ULAN COAL MODIFICATION 6 – UNDERGROUND MINING EXTENSION

Submissions Report

Project Director: Kirsty Davies
Project Manager: Kirsty Davies
Report No. 20020/R11
Date: August 2023

FIGURE 3.1
Amended Infrastructure Layout

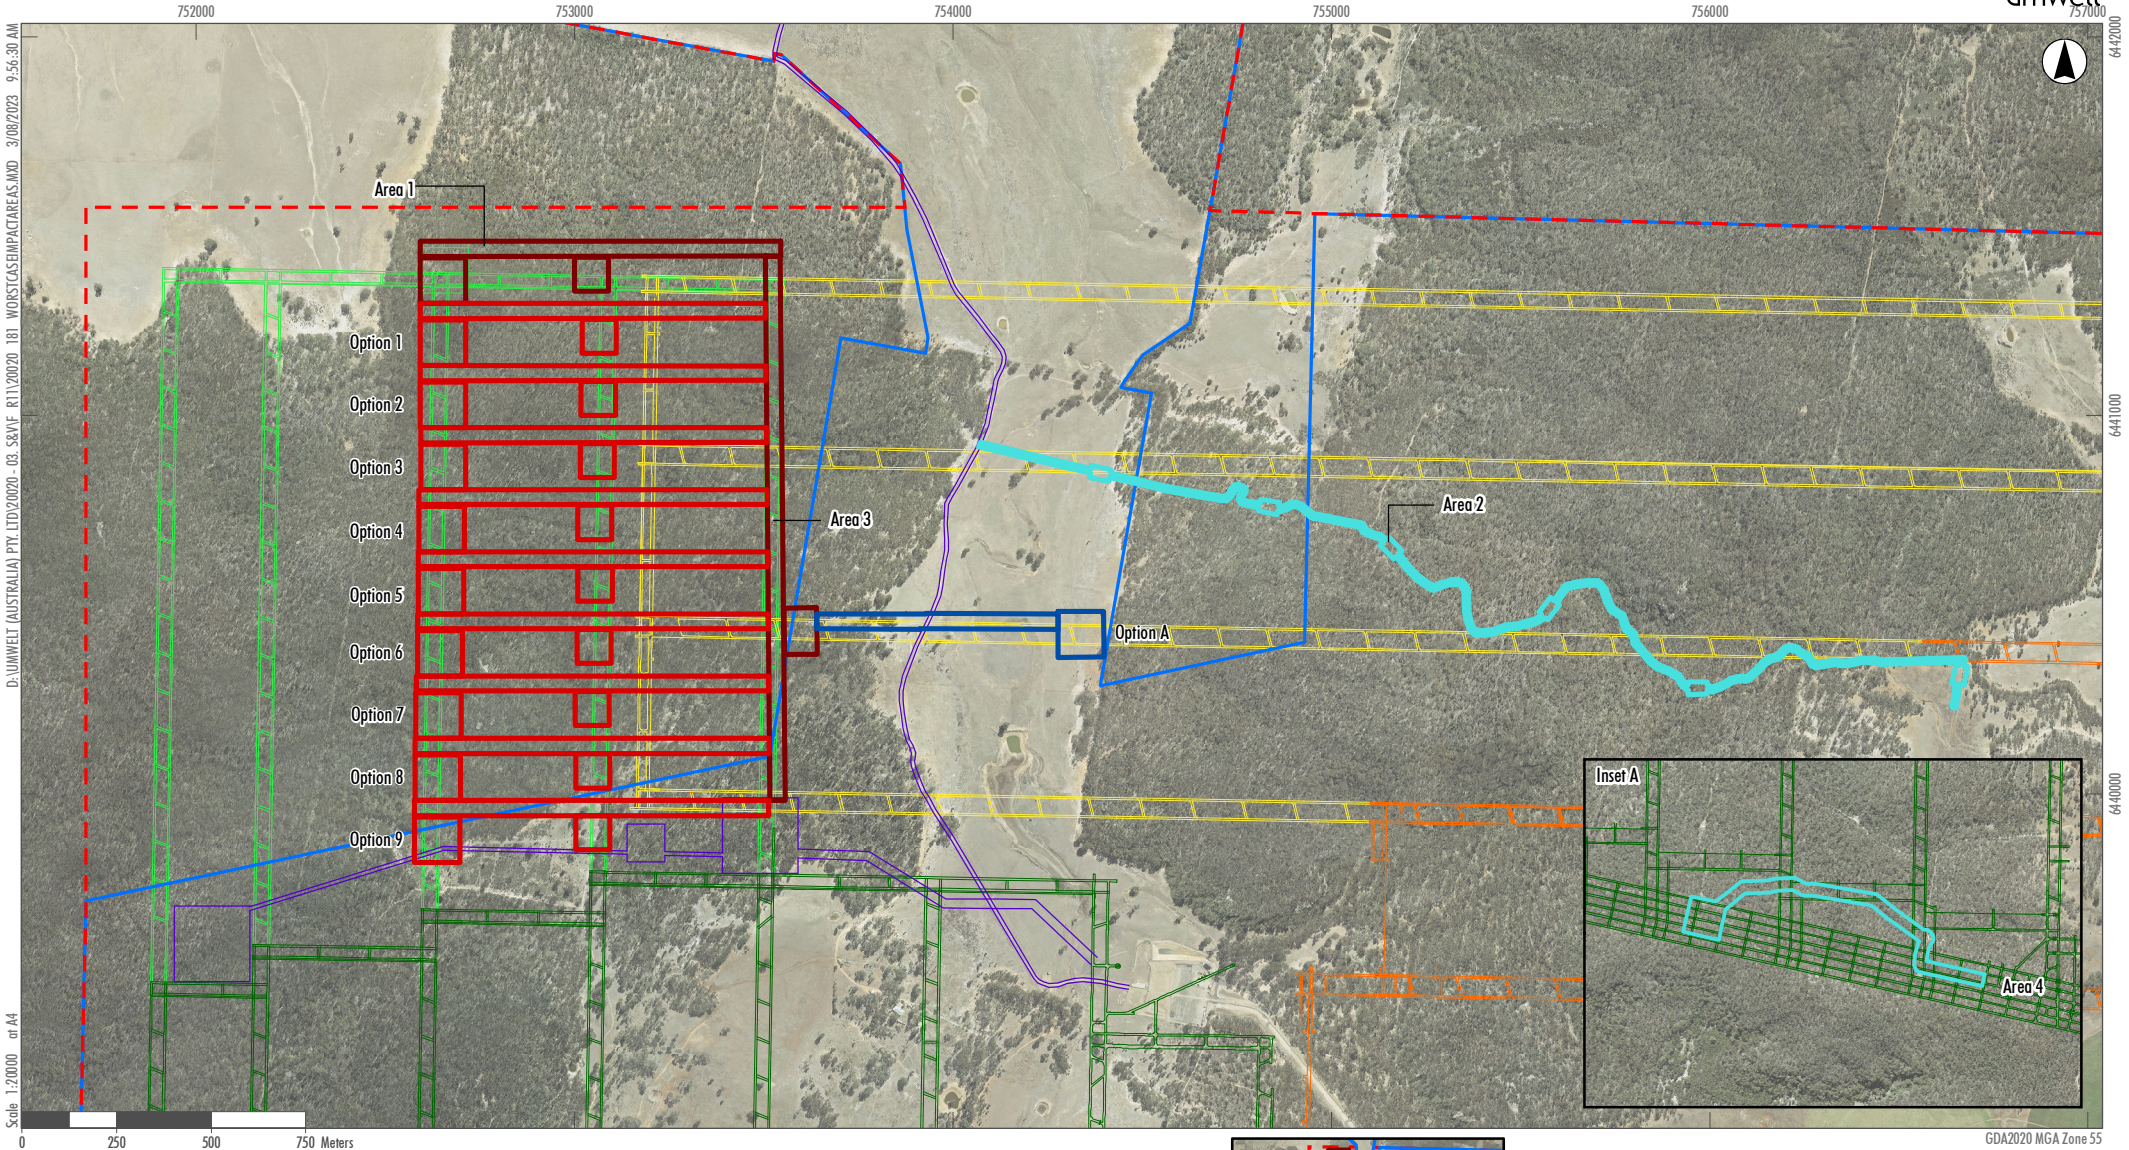
As a result of ongoing mine design, improved understanding of mining and geological conditions and in consideration of responses on the Modification Report (Umwelt, 2022), UCMPL has made refinements to the proposed surface infrastructure to support the additional underground mining at the UCC.

In order to further avoid ecological impacts, UCMPL has:

- removed three proposed dewatering bores and associated infrastructure corridors
- removed proposed contingency Ulan Underground ventilation options and associated infrastructure corridors
- refined proposed Ulan West infrastructure access corridors
- refined the proposed access track.

The Proposed Modification includes a preferred surface infrastructure footprint (as shown on **Figure 3.1**) with a worst-case option on potential alternative footprints (refer to **Figure 3.2**). The Biodiversity Development Assessment Report (BDAR) has been amended to consider the changes to the proposed surface infrastructure layouts and amended approach to alternate footprints (refer to **Section 3.3**). Under the worst-case assessment, the Proposed Modification has been assessed as potentially having a direct impact of up to 26.1 ha of native vegetation communities, a reduction of 11 ha. This assessment is conservative and the Proposed Modification will not ultimately result in the removal of 26.1 ha of native vegetation.
